Petition Number: 2023-042
General Location Identifier: 11907801

From: Jake Carpenter, PE Reviewer: Patrick Monroe

Date	Description	
7-26-23	First Review (PM)	
8-23-23	Second Review (PDM)	
11-27-23	Third Review (JP)	
12-20-23	Fourth Review (JP)

Transportation Summary

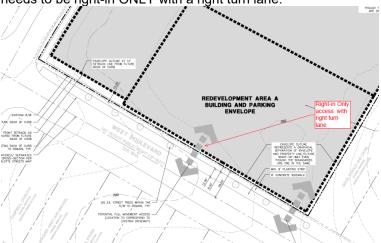
- Under future UDO guidelines this project would require a Comprehensive Transportation Review and mitigation. In leu of providing CTR, CDOT REQUESTS the petitioner provide APS pushbuttons and pedestrian ramp upgrades at the existing traffic signal at the intersection of West Boulevard and South Mint Street.
- 4. Outstanding Comment from 7.26.23: In coordination with NCDOT, revise site plan and conditional note(s) to commit to construct bicycle facilities by installing a 12' multi-use path on West Boulevard to meet the Council-adopted Charlotte BIKES Policy. Charlotte Streets Map calls for buffered bike lanes, NCDOT will not allow buffered bike lanes on West Boulevard. Multi-use paths maintained by the City shall meet ADA/PROWAG requirements.

Clarifying Comment from 11.27.23: Proposed streetscape is only 8'. Due to NCDOT not wanting a bike lane on their street, this needs to be a 12' shared use path.

Clarifying Comment from 12.21.23: Revise proposed streetscape to a 12' multi-use path to support council adopted Charlotte BIKES policy.

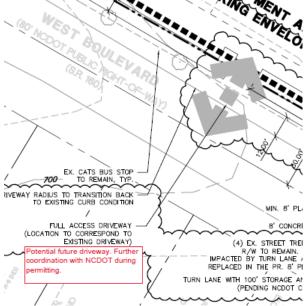
7. Outstanding Comment from 7.26.23: Per coordination with NCDOT, the site access on West Boulevard needs to be right-in ONLY with a right turn lane.

Clarifying Comment 11.27.23: Revise site plane and conditional note to read, "Potential future driveway. Further coordination with NCDOT during permitting."

Clarifying Comment 12.20.23: Although this is an existing driveway, NCDOT has the authority to remove or limit access. Add statement to callout and conditional note that approval of West Boulevard driveway will be coordinated during permitting.

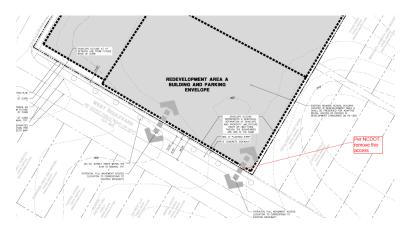
8. Outstanding Comment from 7.26.23: Per coordination with NCDOT, remove this site access along West Boulevard.
